PLANNING & COMMUNITY DEVELOPMENT DEPARTMENT
Land Use Review Division

RE: Amara (Annexation, Mater Plan and Zoning) – Initial Review Comments
File: CPC A 21-00197 – CPC A 21-00207, CPC MP 21-00208, CPC ZC 21-00209

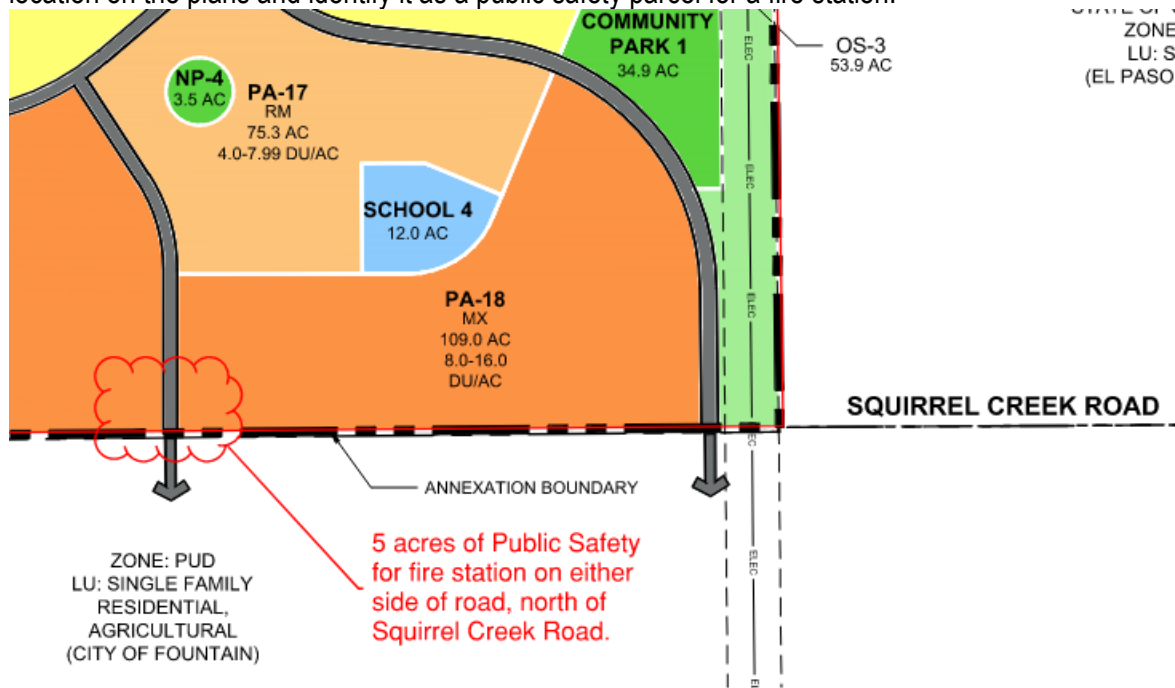
1. Please verify General Note 2. Will Powers Blvd ultimately become CDOT ROW? Is there an agreement between the City and CDOT? Is this note necessary on the master plan? Additional discussion maybe required for the future Powers Blvd ROW and note 2.
